Central Contra Costa Sanitary District

CENTRAL CONTRA COSTA SANITARY DISTRICT'S RESPONSE TO TENTATIVE ORDER NO. R2-2007-xxx, NATIONAL POLLUTANT DISCHARGE ELIMINATION SYSTEM PERMIT NO. CA 0037648

ENCLOSURE 1

SUGGESTED CHANGES TO TEXT

22. Attachment C C-2. Wastewater Flow Schematic

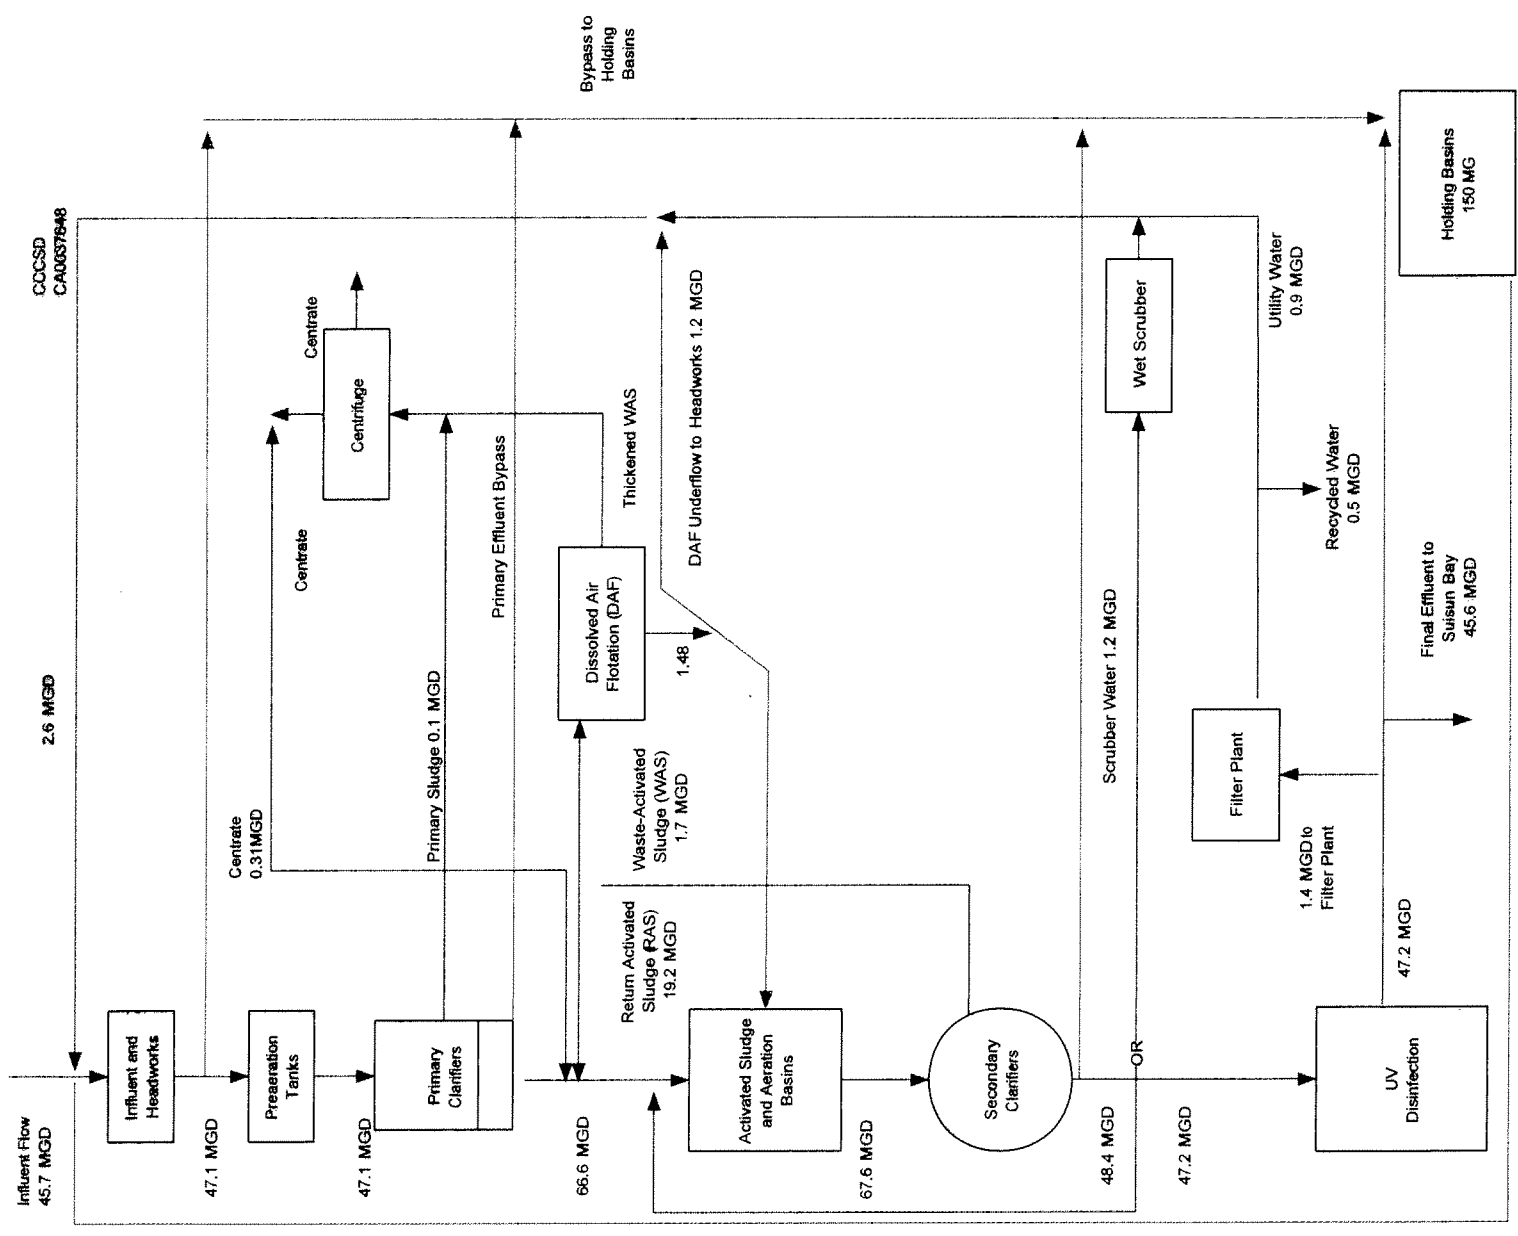
Please replace the existing page C-2, Wastewater Flow Schematic, with the attached, revised page C-2, Wastewater Flow Schematic. Note that the revised Wastewater Flow Schematic correctly shows the scrubber water flow diversions.
